## Lower Pearl River Basin Task Force

**SUBJECT: Rankin-Hinds Pearl River Flood & Drainage Control District - One Lake Proposal  
Integrated Draft Feasibility & Environmental Impact Statement (DFEIS)**

## **St Tammany Parish comments on the *Pearl River Basin, Mississippi Section 211 Feasibility Study - Integrated Draft Feasibility and Environmental Impact Statement***

Figure 2. Pearl River Reach near Proposed Alt. C Impoundment with Flow Characteristics

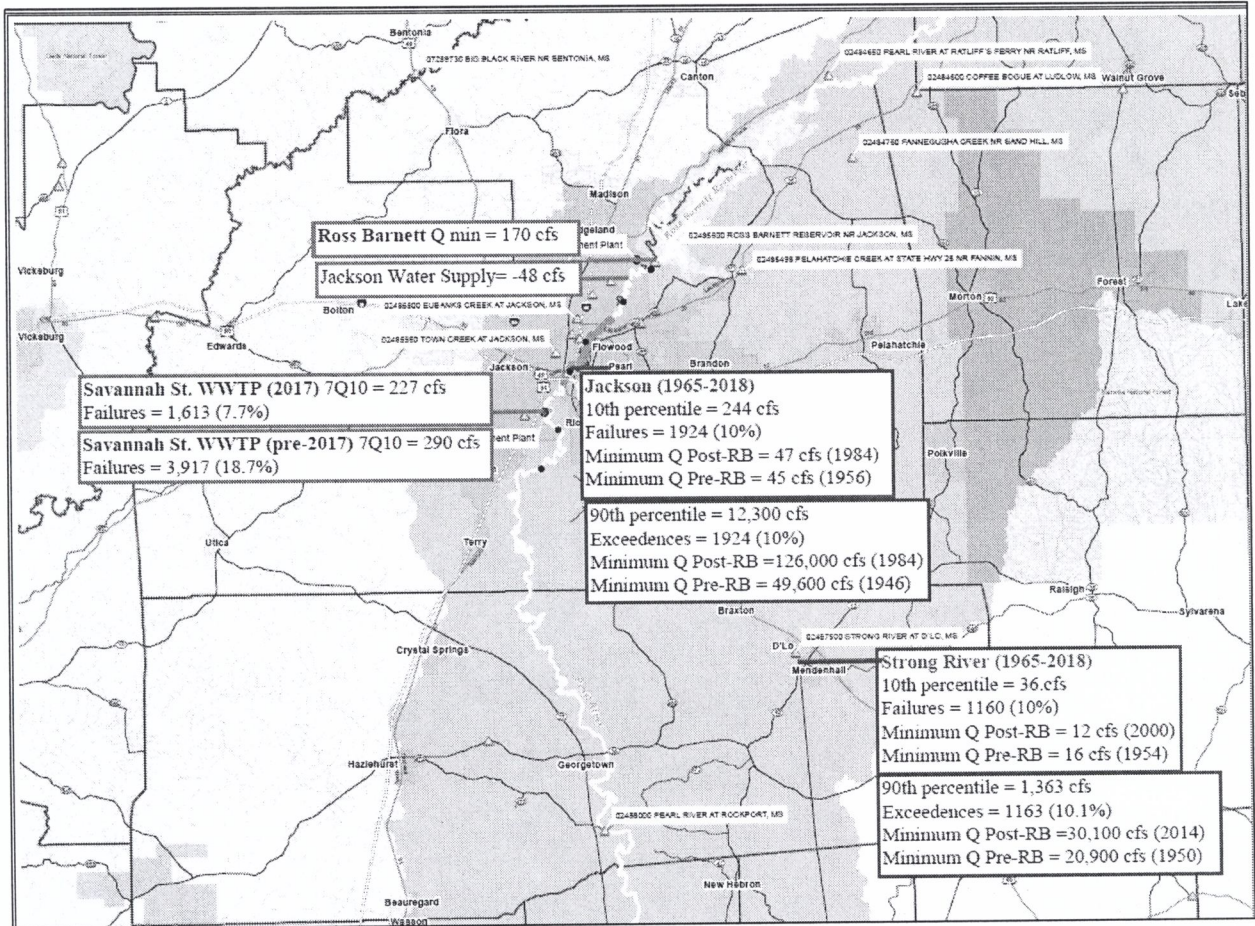
Construction of the Ross Barnett Reservoir (RB) began in 1960 and was completed in 1963. The 33,000 surface acre lake reached “full-pool” capacity in 1965<sup>1</sup>. Following construction of the Ross Barnett Reservoir near Jackson, MS, Minimum Mean Daily Discharges have remained approximately the same, from 45 cfs (10/5/1956) to 47 cfs (6/14/1984) for pre-RB versus post-RB, respectively (Figure 2).

**Figure 3. Mean Daily Discharge for USGS 02486000 (Pearl River at Jackson, MS) for the period of record**

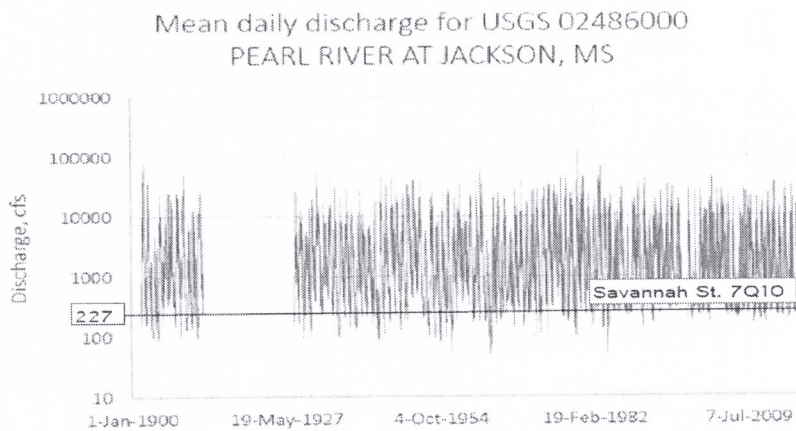
A 7Q10 of 227 cfs is the minimum stream baseflow measured on the USGS gage at Jackson required by MSDEQ for the most recent permit renewal (2017) for the 46 MGD City of Jackson Savannah St. WWTP discharge. Post-RB, there were 1,613 failures (7.7%) to meet this minimum flowrate (Figure 1). Mean Daily Discharge on the gage at Jackson show many measurements that are lower than the required 227 cfs for City of Jackson, Savannah St. Wastewater Treatment Plant (WWTP), as seen on the hydrograph in Figure 3.

The previous NPDES permit for the Savannah St. WWTP set the stream baseflow at 290 cfs for which there were 3,917 failures (18.7%). It seems counter intuitive that the permit should have been issued with a lower stream baseflow, with the River’s history of not attaining adequate flow. A TMDL for Nutrients<sup>2</sup> was implemented by EPA and MSDEQ in 2015 for the Pearl River from Ross Barnett to the Strong River. It seems plausible that inadequate stream baseflow at the Jackson gage during summer-critical conditions may be contributing to the lack of assimilative capacity at this location in the River incurring the TMDL.

- It is strongly suggested that the Ross Barnett Reservoir minimum discharges be increased.

**Figure 4. Pearl River Reach near Monticello, MS with Flow Characteristics**

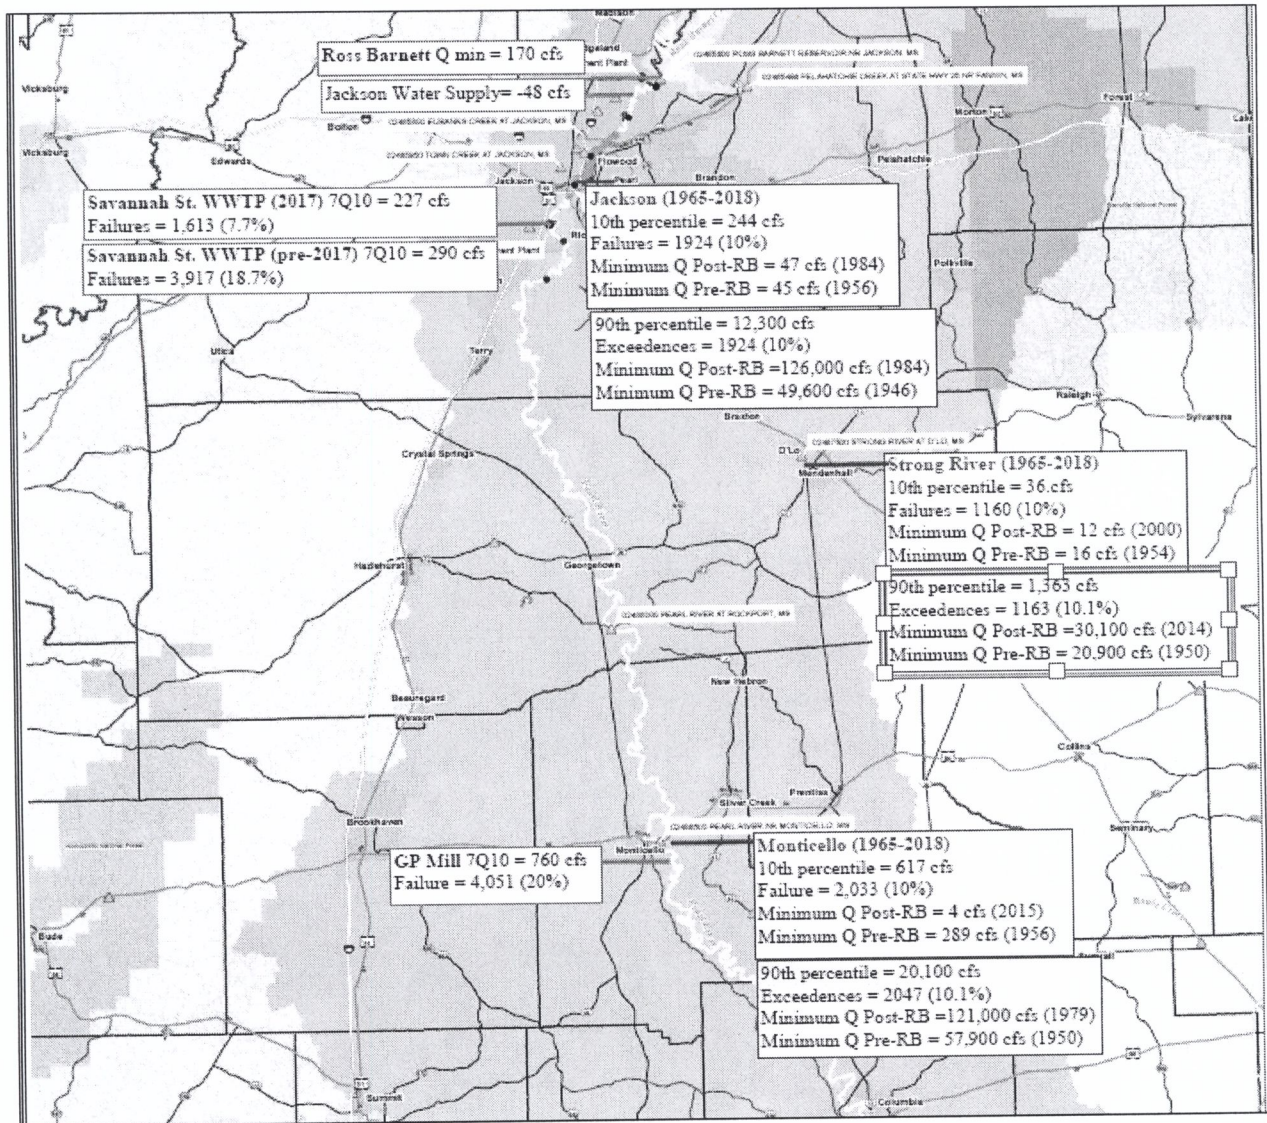
Monticello, MS is the location of a large NPDES discharger, Georgia Pacific (GP) Paper Mill (Figure 4). The 10<sup>th</sup> percentile flow post-RB is 512 cfs measured at the gage USGS 02488500 Pearl River at Monticello, MS, of which there were 854 measurements that failed to meet the 10<sup>th</sup> percentile (11%). The historic minimum flow at that location is 4.02 cfs. Residents along the River relay stories that the water was so low at that time that one could walk across to the other bank.

The 7Q10 for the 26.04 MGD (40.3 cfs) GP facility requires a stream baseflow of 760 cfs. There were 4,051 Daily Mean Discharge measurements (20%) that failed to meet that minimum. The Strong River, upstream of the Monticello gage, augments flow at this location (Figure 1); however, the post-RB 10<sup>th</sup> percentile for the Strong is 36 cfs measured at USGS 02487500 Strong River at D’Lo, MS. 1,160 Daily Mean Discharges failed to meet the 10<sup>th</sup> percentile (10%). The historic minimum was 12 cfs (8/31/2000).

- Clearly, stream baseflow, even with augmentation from the Strong River, is inadequate to meet the permit needs for this facility.

**Figure 5. Pearl River Reach near Bogalusa, LA with Flow Characteristics**

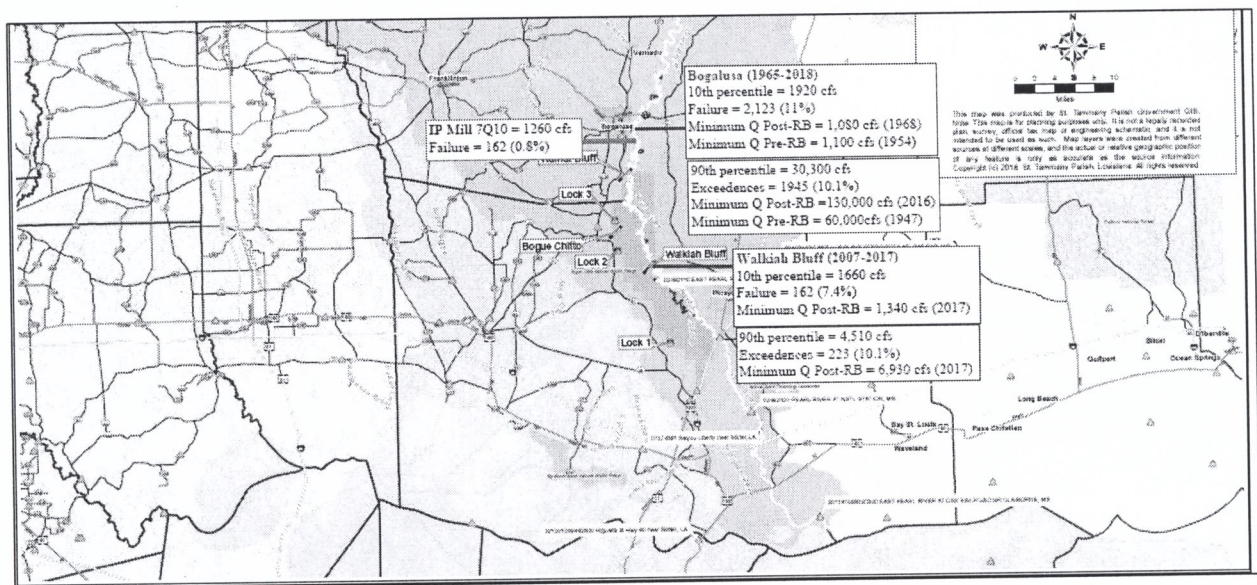
Bogalusa, LA is the location of a large NPDES discharger, International Paper (IP) Mill (Figure 5). The 10<sup>th</sup> percentile flow post-RB is 1,920 cfs, of which there were 2123 Daily Mean Discharges that failed to meet the 10<sup>th</sup> percentile (11%). The historic post-RB minimum flow at that location is 1,080 cfs. The 7Q10 for the 16 MGD (24.8 cfs) IP facility requires a stream baseflow of 1,260 cfs. There were 162 post-RB Daily Average Discharge measurements (0.8%) that failed to meet that minimum. While the minimum stream baseflow for this facility was well determined for the permit, there is little margin of safety in the stream baseflow, potentially incurring in-stream water quality violations during summer-critical conditions.

- There is a need for additional stream baseflow augmentation at this location in the Pearl River.

This site is of particular interest to oyster culture in coastal MS and LA (Figure 5). Adequate freshwater during summer critical conditions is necessary to mitigate the effects of saltwater intrusion and survivability of oysters in Lake Pontchartrain and the Mississippi Sound. Walkiah Bluff was constructed by the USACE to divert freshwater to the East Peal River during low-flow conditions. The 10<sup>th</sup> percentile Daily Mean Discharge measured at this gage is 1,660 cfs, of which 162 measurements <10<sup>th</sup> percentile (2007-2018). The historic minimum flow was 1,340 cfs (10/15/2007). A significant amount of debris is reportedly blocking the structure’s weir lessening the amount of fresh water being diverted.

- It is suggested that the USACE conduct maintenance on the Walkiah Bluff structure to restore its capacity.

**Figure 6. Minimum Mean Daily Flows by Month minus proposed evaporative losses**

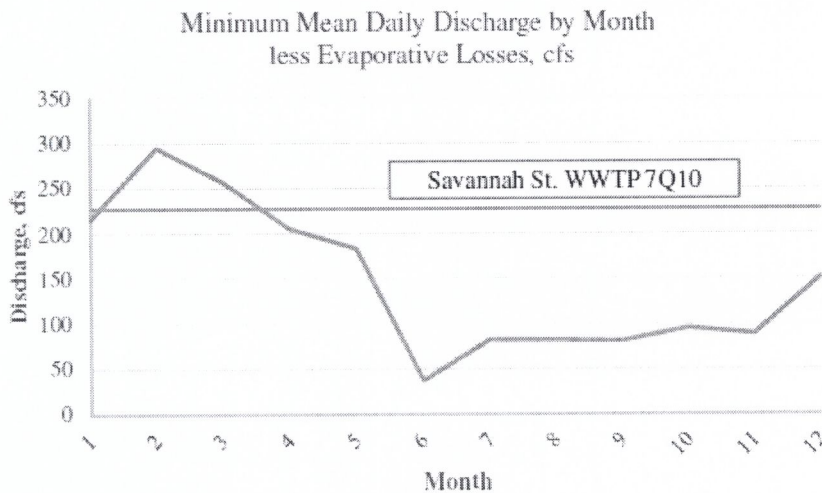
- Evaporative losses subtracted from either the Minimum Daily Mean Discharges by Month (Figure 6) or the 10<sup>th</sup> percentile of Mean Daily Discharges (Table 5) indicate the already-impacted Pearl River will be further compromised.

- A geotechnical investigation is needed in order to determine whether there will be gains or losses in the proposed impoundment due to groundwater effects.

Figure 9. Predicted DO vs Observed DO at Sample Location downstream of the Ross Barnett gates

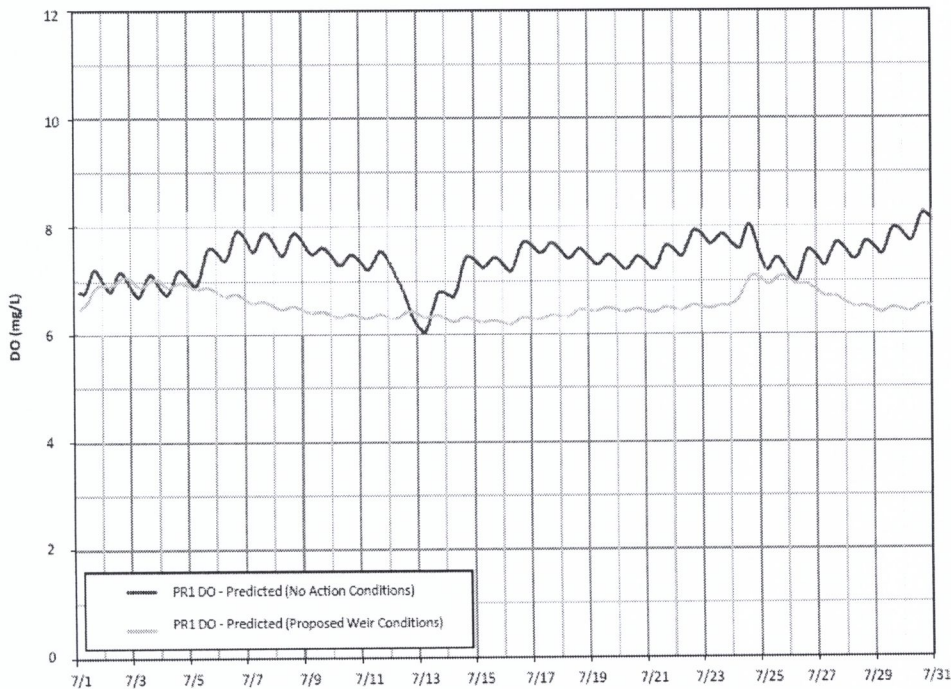
Using data from the July 2014 sampling event, the EIS team developed a model to predict the impact of the proposed impoundment. Figure 9 (EIS Appendix D, Water Quality, pg.119) presents model output of dissolved oxygen (DO) for two scenarios: 1) “No Action” (current conditions) and 2) Alternative C scenario. In the “No action” scenario, DO is significantly higher than the Alt. C scenario; however, EIS reviewers are assured that the DO in the Alt. C scenario will remain above the CWA criteria of 5.0 mg/L. Reviewers are asked to believe that the flow rates, pollutant concentrations, temperatures and decay coefficients used in the model are also correct. Assuming the 10<sup>th</sup> percentile flow rates were to be used, it is doubtful that the DO would maintain CWA DO minimums.

- In reviewing the discharge from the proposed Alt. C impoundment, MSDEQ and USACE are encouraged to require compliance with the CWA anti-degradation standard upon submittal of the final EIS and again at the USACE permit application.

**Figure 10. Locations of Coastal Restoration Projects and CRMS sites in the Pearl River vicinity**

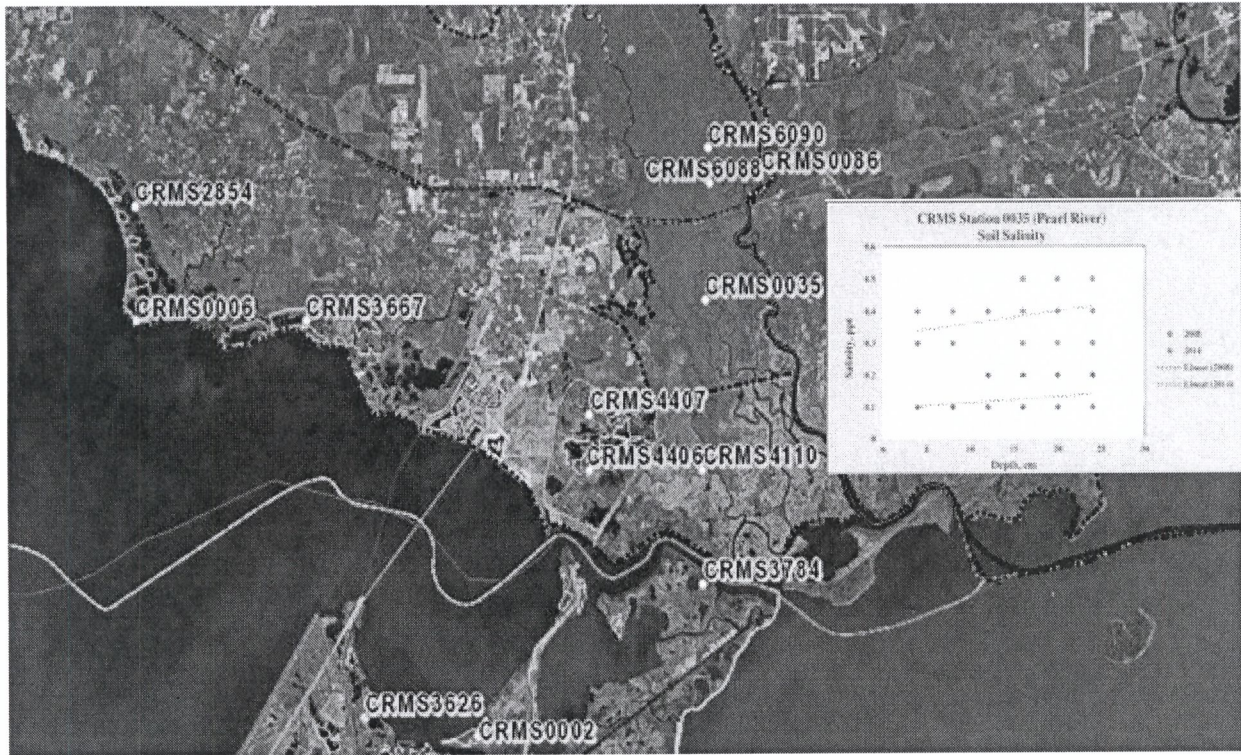
Since 2006, the Louisiana Coastal Protection and Restoration Authority (CPRA) and the US Geological Survey (USGS) have developed and maintained a Coastwide Reference Monitoring System (CRMS) for wetland restoration efforts. There are three CRMS sites in the vicinity of coastal Pearl River and a number of coastal restoration projects that are in the construction or engineering/development phase (Figure 10). These projects are vital to the restoration and resiliency of the Louisiana coastline and provide surge protection to inland communities.

The CRMS site houses monitoring datasets of hydrogeomorphological parameters that characterize coastal habitats in Louisiana. Some of the parameters that are monitored include water level, soil porewater salinity, percent organic content and surface elevation/accretion. The CRMS site link is: <http://www.lacoast.gov/crms2/Home.aspx>. All CRMS indicate increased saline concentration in porewater, perhaps attributable to less fresh water flowing down the Pearl River in low flow months.

- St. Tammany Parish recommends that monitoring at the CRMS sites continue, particularly to monitor for salt water intrusion.
